Planning Commission Regular Meeting

Monday, January 26, 2026, 6:30 PM
106 Center Street

ADDITION & REMODELING FOR:
BENNETT RESIDENCE
150 BELL STREET
EXCELSIOR, MN

② Rear Elevation
1/4" = 1'-0"

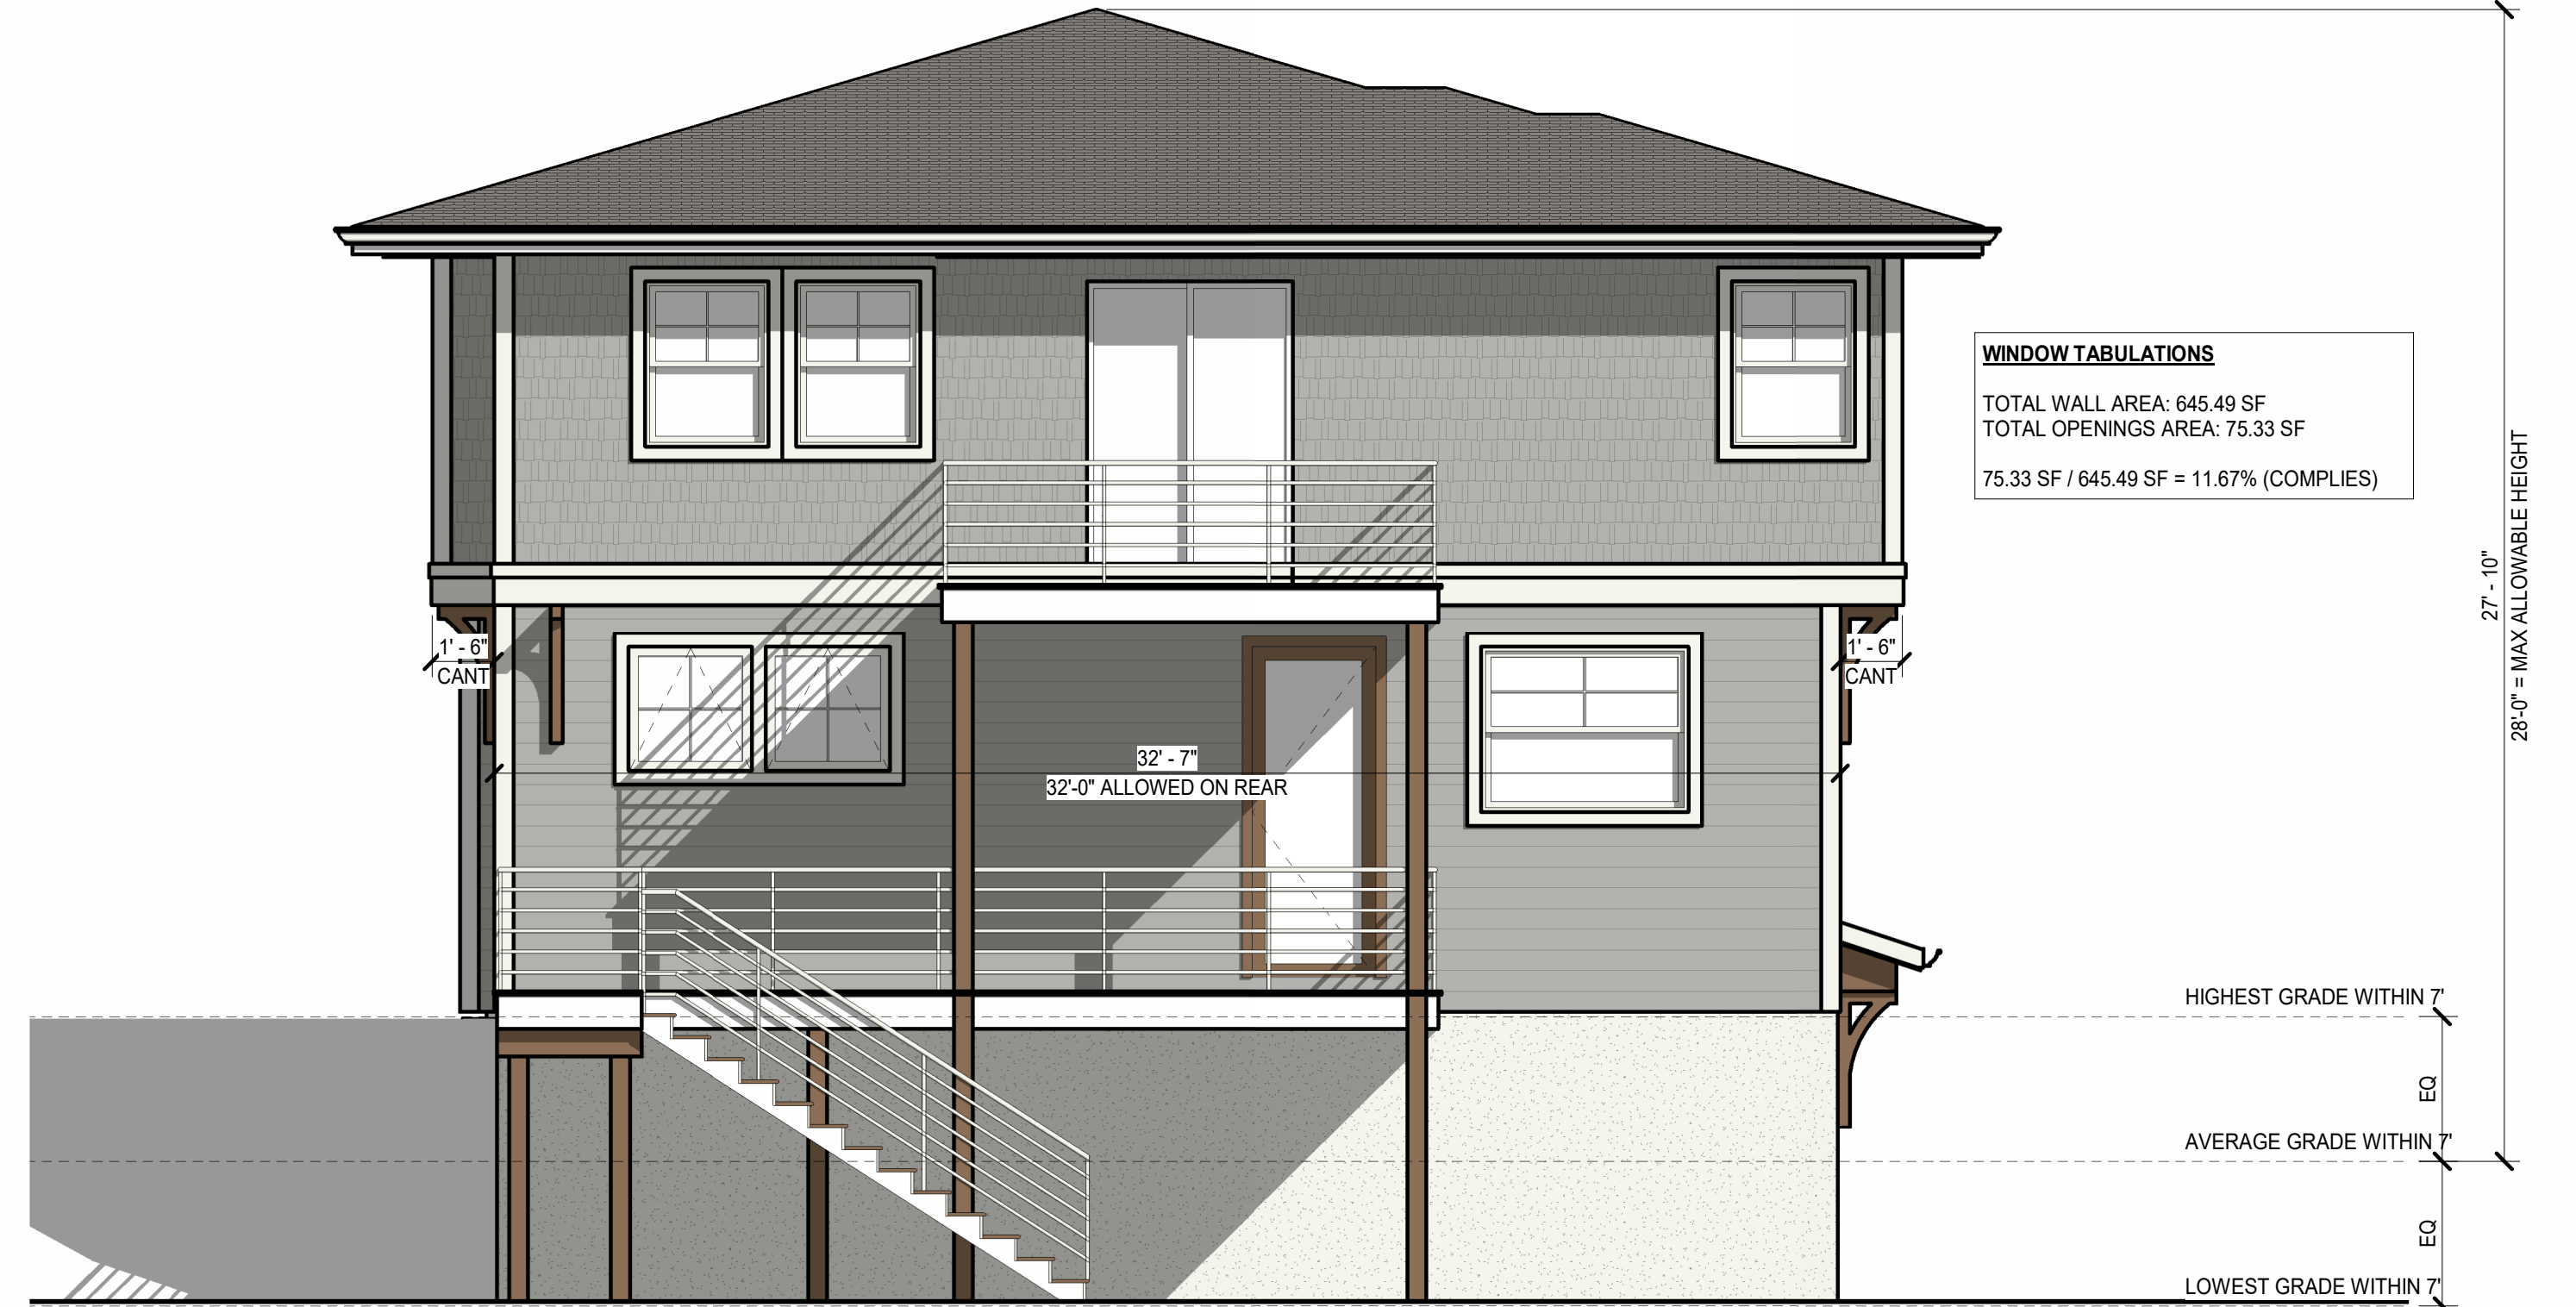
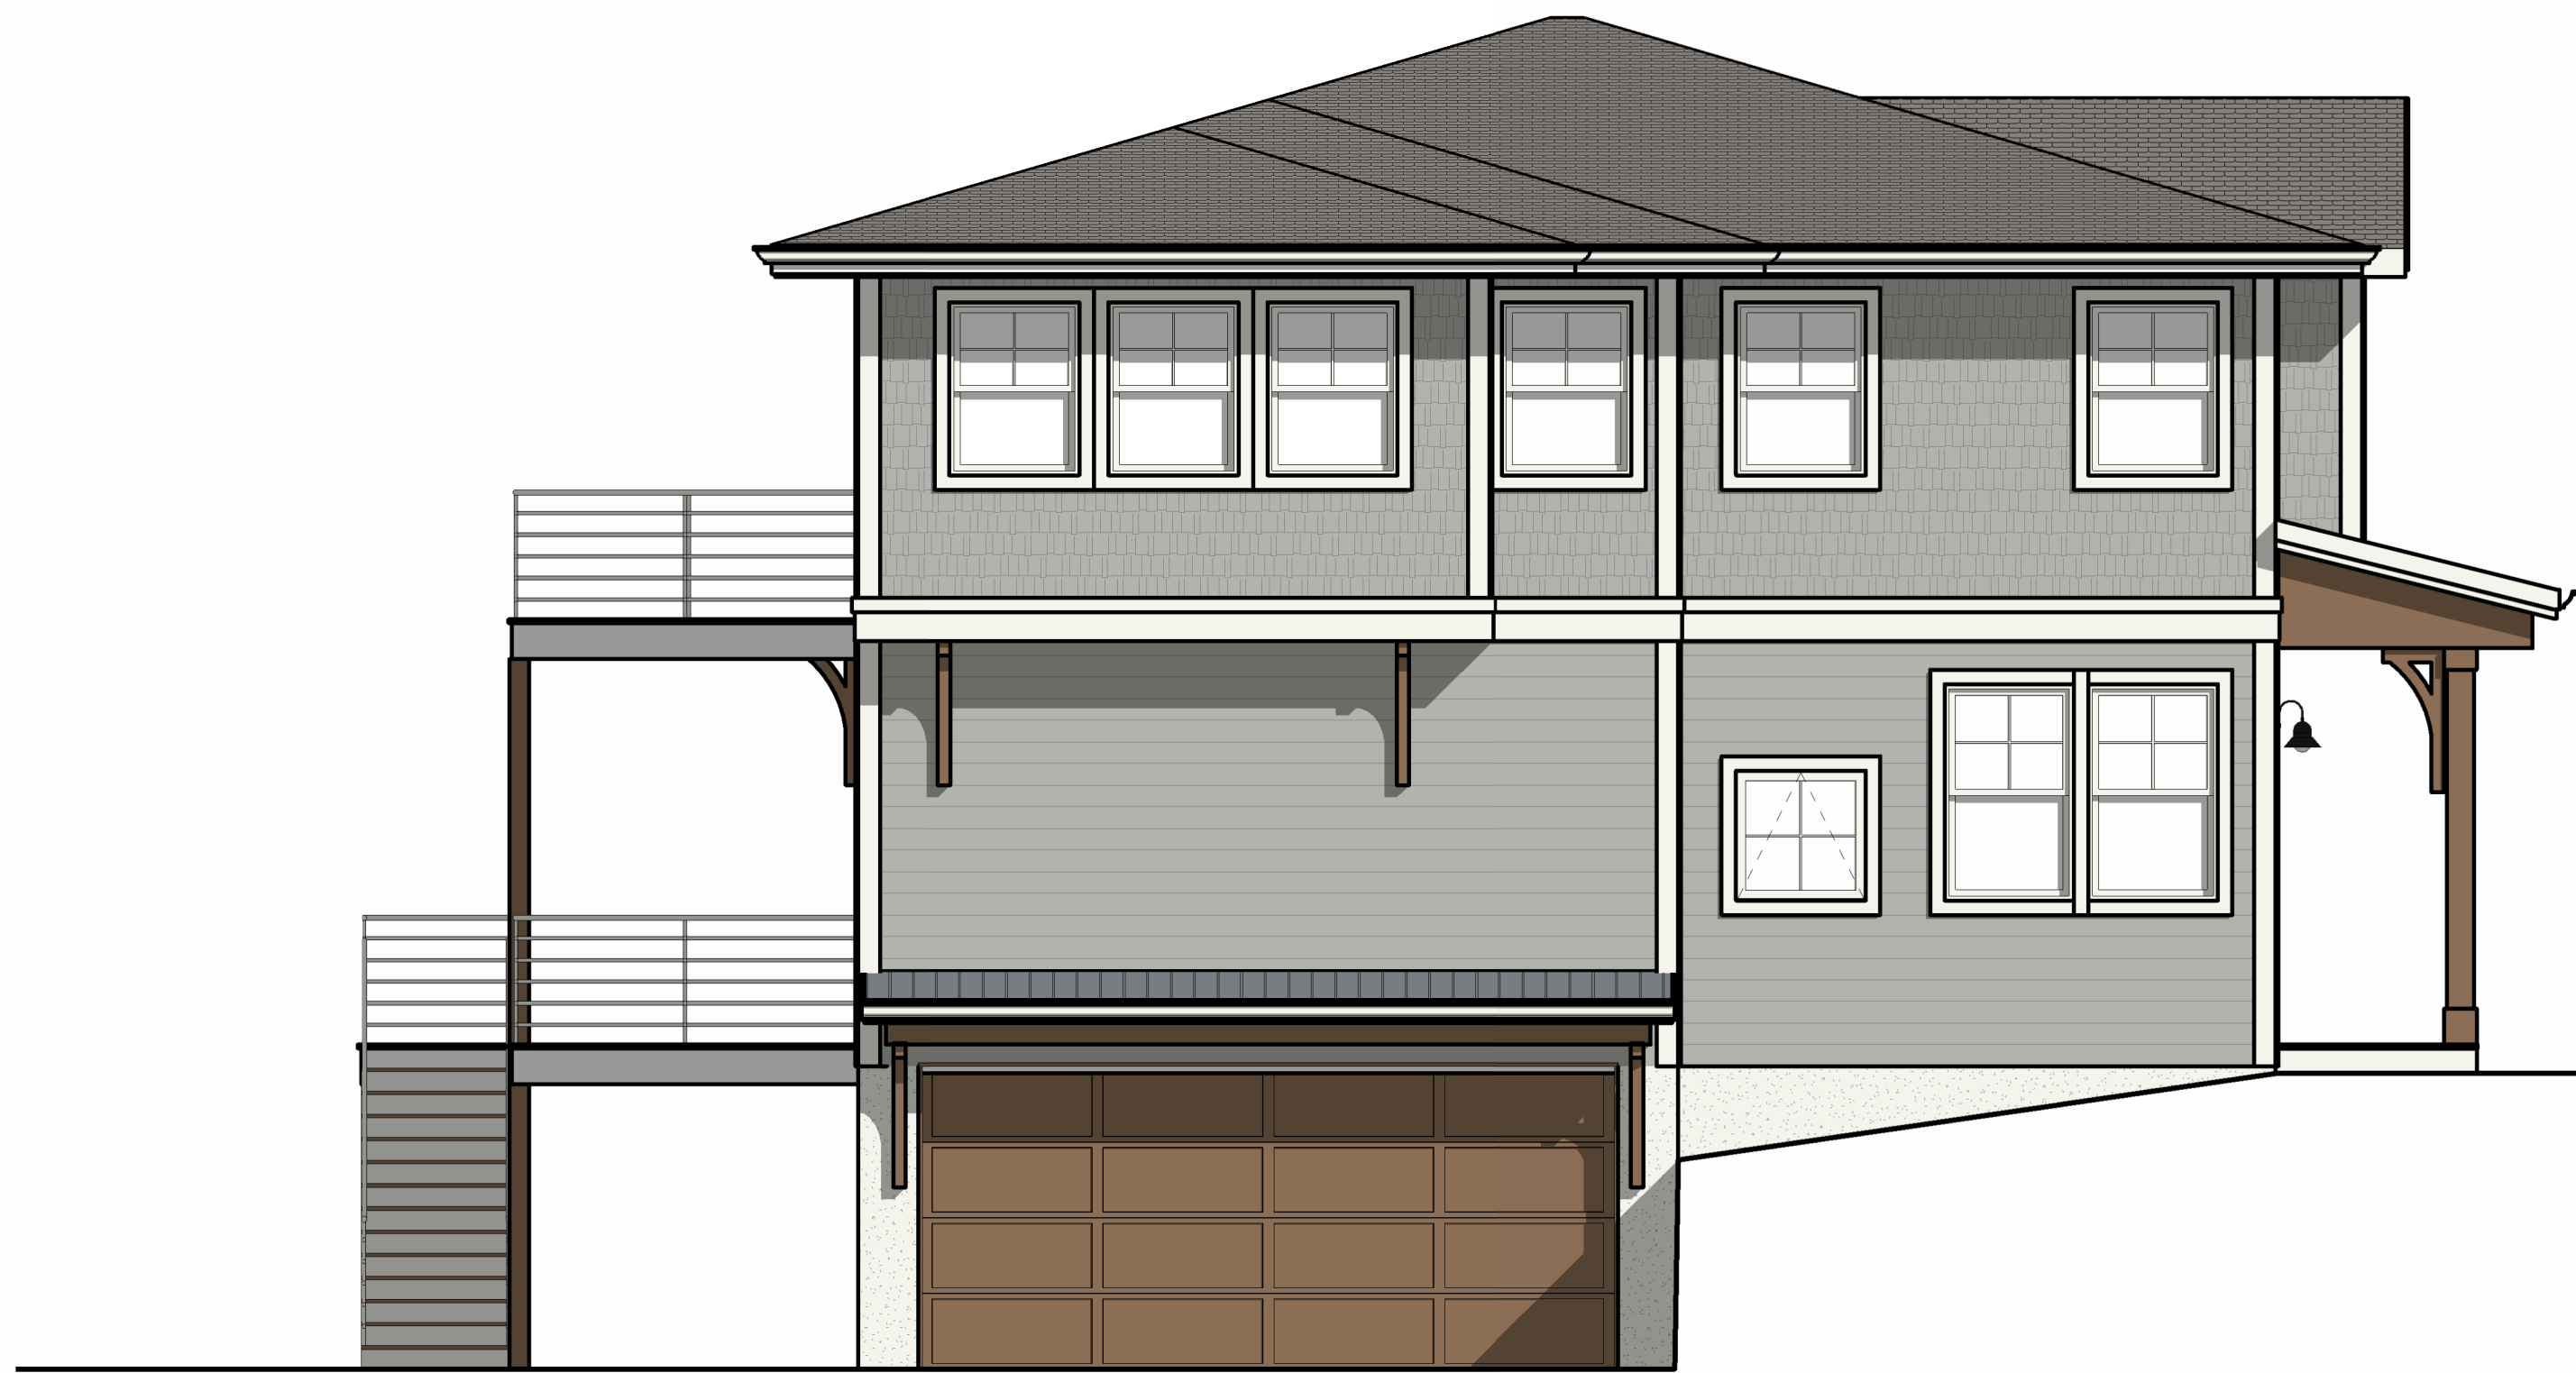
from the lowest elevation within the 7' area around the structure. The proposed home also requires a variance from wall plane requirements. The proposed home includes cantilevers within the design, however, these cantilevers do not meet the minimum size requirements for offsets on wall planes. Sec. 41-10 requires that exterior side and rear walls shall not exceed 32 feet without a minimum of at least a two-foot deep by eight-foot-wide offset (projecting or recessed) within every 32 feet or less.

The applicant submitted architectural elevations which shows the home has been designed to be viewed from multiple angles. It is well detailed on all four sides. The use of windows and decorative brackets provide design details to the home. Increasing the projection of the proposed cantilever on the right side of the building would prevent the need for a side wall plane variance.
